A14 Cambridge to Huntingdon  
improvement scheme

# Transport Review of the Swavesey Interchange

1 July 2015

For and on behalf of  
**Coalition of local Parish Councils**

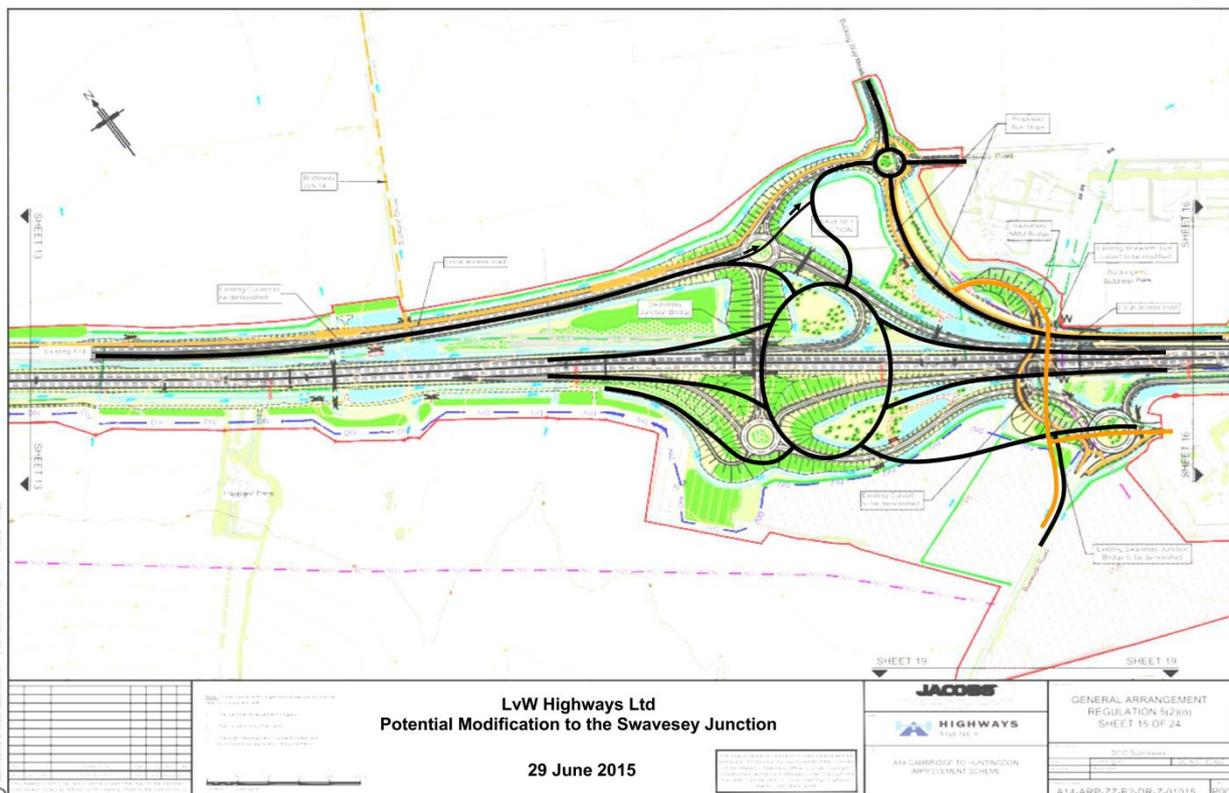
- 5.1 We have undertaken a review of the design and can understand how the proposed design was developed based on the predicted flows and geometric requirements set out in the Design Manual for Roads and Bridges. It is felt however that the design is overcomplicated and would benefit from a re-design based on a more conventional two bridge layout.
- 5.2 It has been suggested by residents that a main aim of the A14 improvement was to separate local traffic from through traffic on the trunk road. On this basis they do not understand why two major junctions at Swavesey and Bar Hill are so close together and both cater for all traffic movements. The main reasons appear to be the related land uses adjacent to each junction; at Swavesey the requirements are obviously influenced by the needs of the service area which

- 5.3 If the Swavesey junction was just connected to the new parallel 'old A14' local road there would be a need for a second junction for the service area which would have to have connections to both directions of traffic on the new A14. Removal of a full junction at Swavesey could also have required an additional junction to the north of Hilton on the B1040 to cater for traffic from St Ives. We therefore do not consider that the Swavesey junction could just cater for local traffic but think that a much more understandable layout could be created within the same land area.

- 5.4 From the data provided in the Transport Assessment it is estimated that maximum peak hour flows in 2035 could be in the region of 4300 vehicles in the am peak hour and 4700 vehicles in the pm peak hour. These flows will have been modified by the latest CHARM3a modelling and due to the lower growth figures should have been slightly reduced. For this level of flow it is considered that a layout as indicated below would be much easier to understand by all road users. The design has not been tested for capacity but with this level of flow should work as a conventional roundabout. If capacity issues did occur then certain arms of the junction such as the off-slip roads from the A14 could be signalised.

- 5.5 The design should be more acceptable to the service area with a direct access off the roundabout and allows a reduction in the standard of connection to the Boxworth Road to a T junction. With suitable restrictive traffic calming to the Boxworth Road formed from sections of one-way working close to the new T junction it is likely that southbound through trips would be deterred from using the route through the villages.

- 7.7 In order to simplify the design a layout is shown in para 5.4 based on a conventional grade separated roundabout. The junction would then be formed from two roundabouts rather than four and would provide a direct connection into the service area from the main A14 roundabout. A reduced standard T junction could then be provided as a connection to Boxworth Road.
